To: Environmental Quality/Land Use Committee

From: Steve M. Hundley, AICP, Zoning Administrator

Subject: *Updated Staff Report* - Excep 05-002 – Request for exception to Use and Design Standards for Gasoline Station use, 100 block, Dowdy Drive.

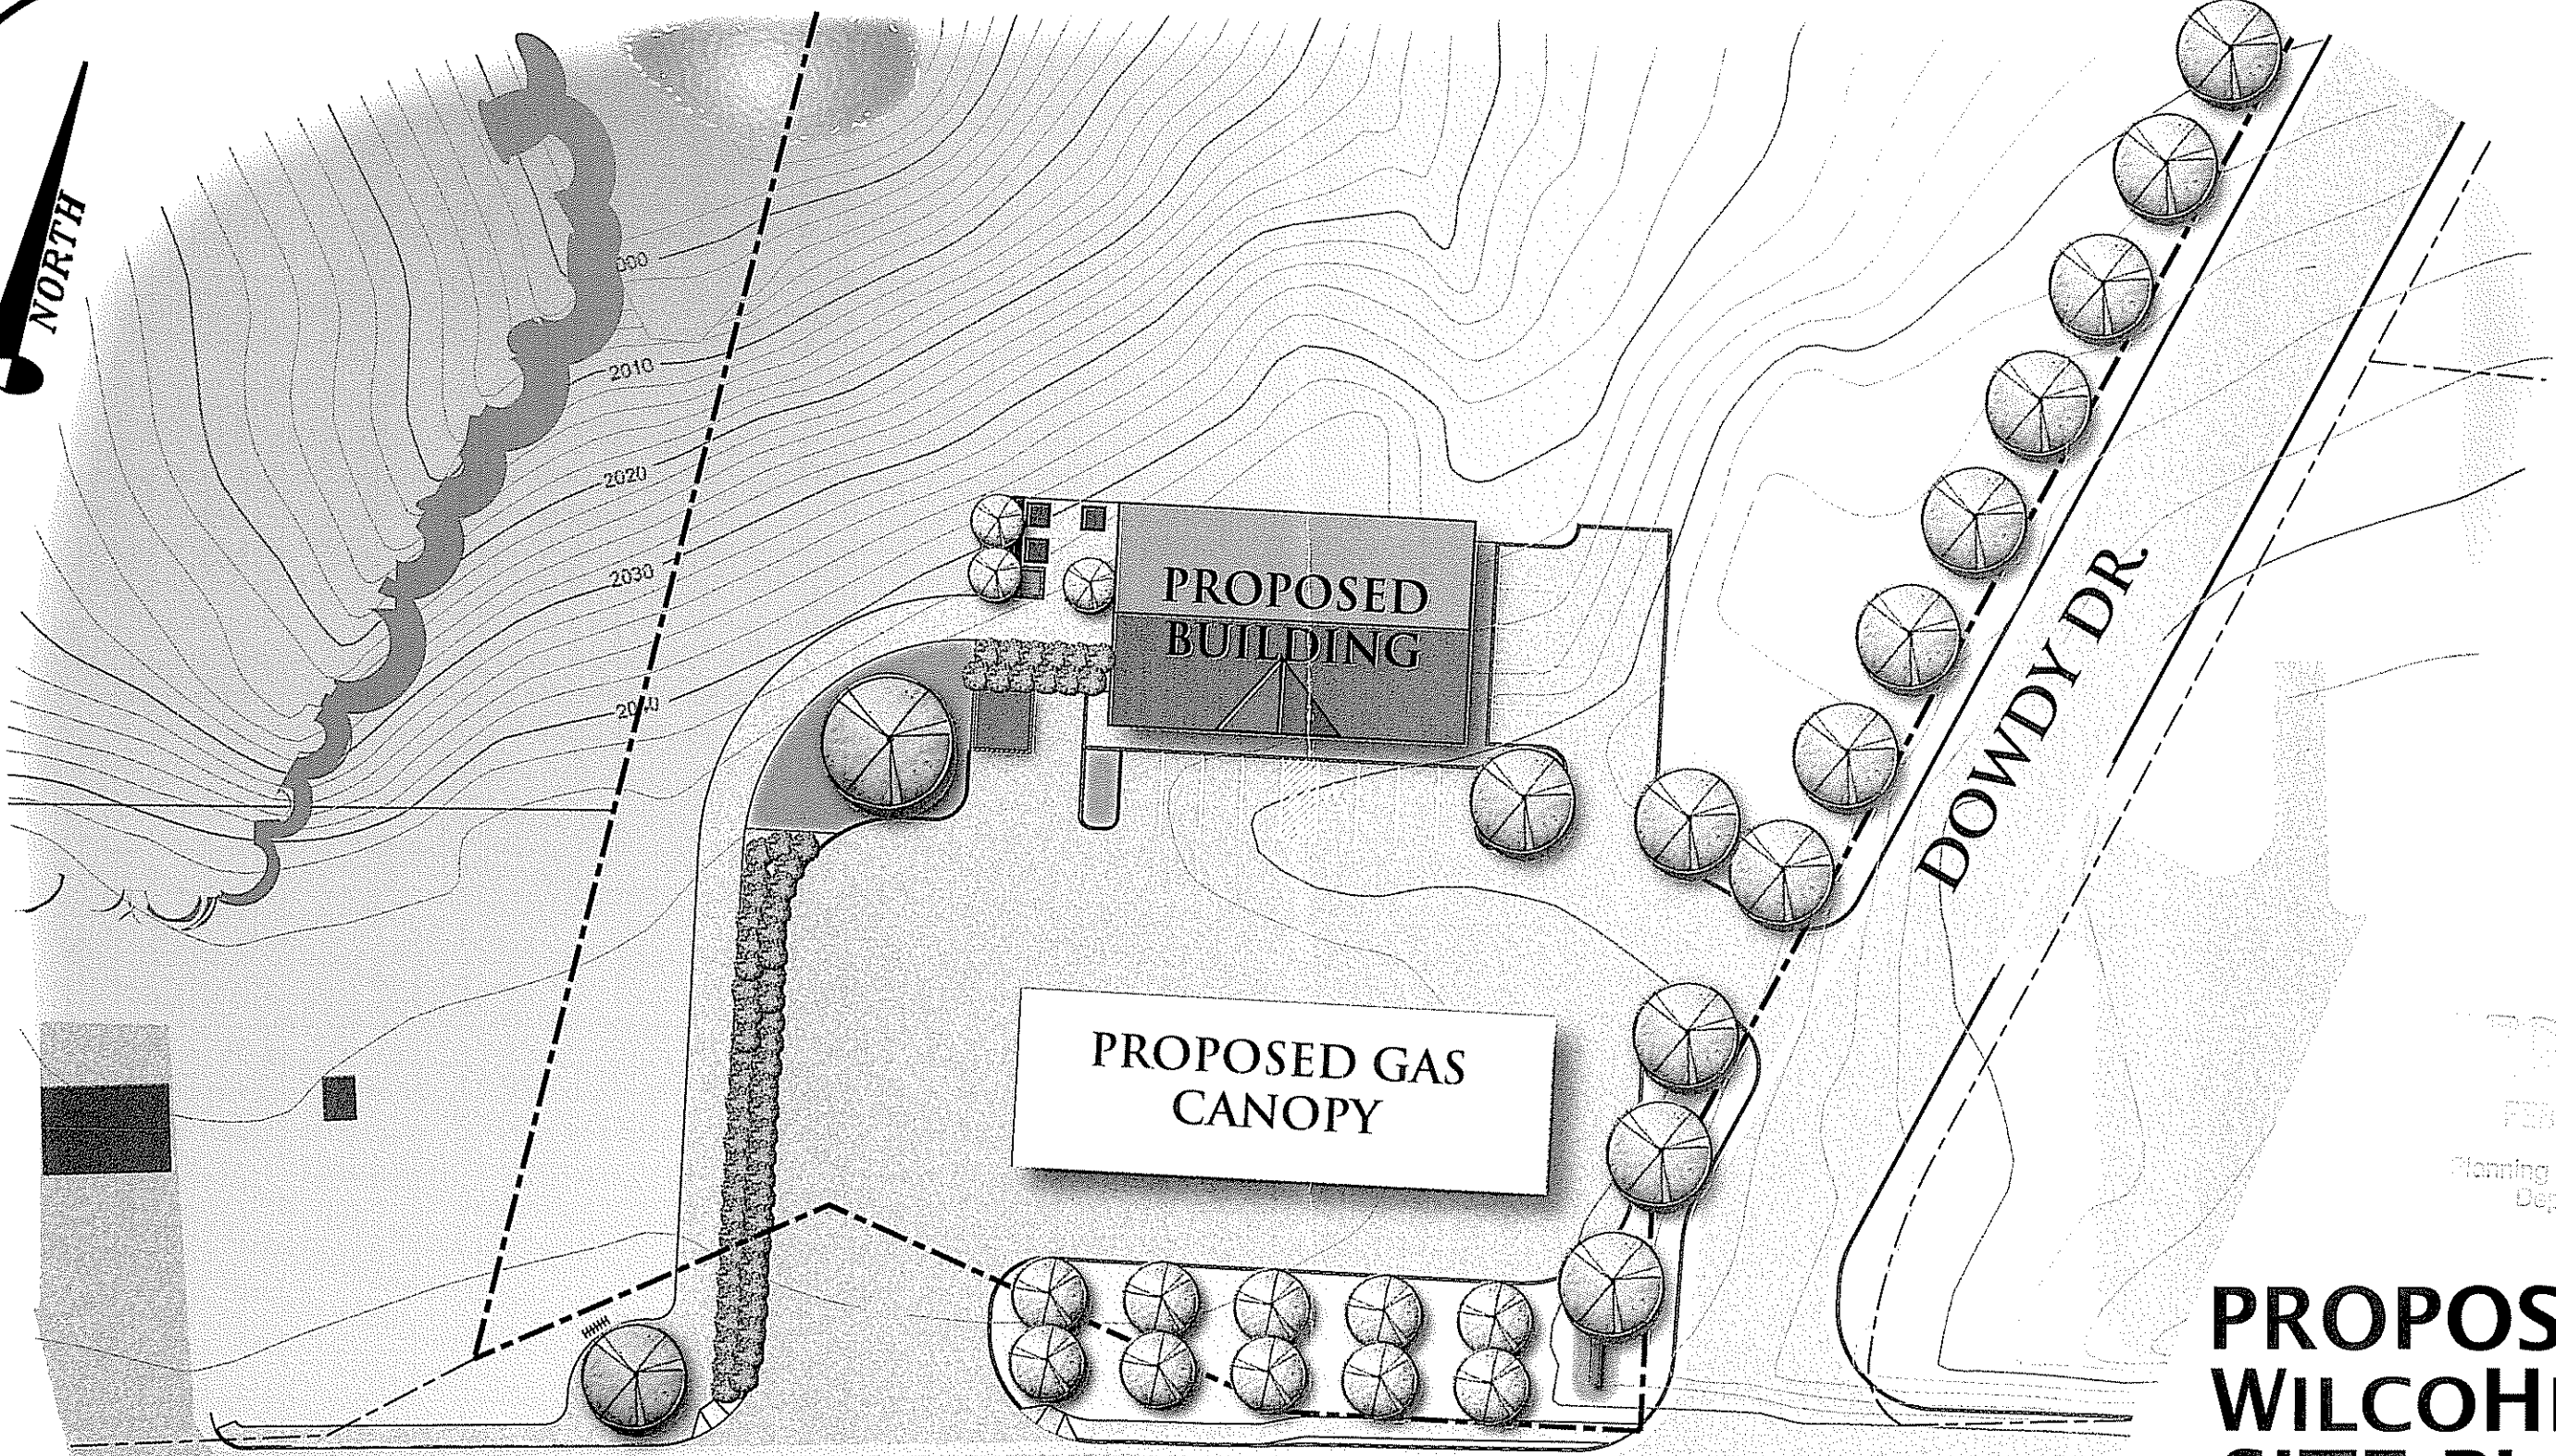
The applicant is now proposing a specific architectural style and materials, as well as a revised conceptual layout for the proposed Gasoline Station use (see attachments). The proposed principal structure is of brick construction with a peak roof. However, the fuel pump canopy is of metal construction with a flat roof. The revised site plan provides some additional landscaping, a walkway from the principal structure to the Main Street public sidewalk and an outside eating area. The principal structure, canopy and parking locations are in essentially the same location as the original site plan.

It should be noted, however, that the proposed architecture and plan do not comply with Section 4527(a)(3). This paragraph reads as follows: “Any canopy over the fuel pumps shall have the same roof shape and exterior materials as the primary structure. Pitched roofs are encouraged.” The applicant may request exception to this section or revise the plan to provide a brick construction, peak-roof canopy, perhaps attached to the principal building.

The Planning Commission may wish to consider the revised site plan and architectural style as a condition of approval of the requested exceptions:

- a. Section 4527(a)(1) fuel pumps shall be located behind the front line of the primary structure;
- b. Section 4527(a)(2) canopy shall be located behind the front line of the primary structure;
- c. Section 4527(d) parking shall be located behind the front line of the principal building.

PROPOSED WILCOHES SITE PLAN

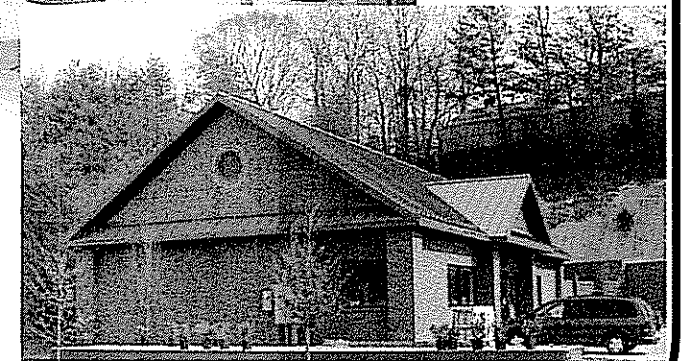
One reason gas pumps and canopies are restricted in location on the site is that they typically appear as segmented visually obtrusive accessory structures. Providing similar architectural style and perhaps connecting the canopy to the principal building helps reduce the negative visual affect.
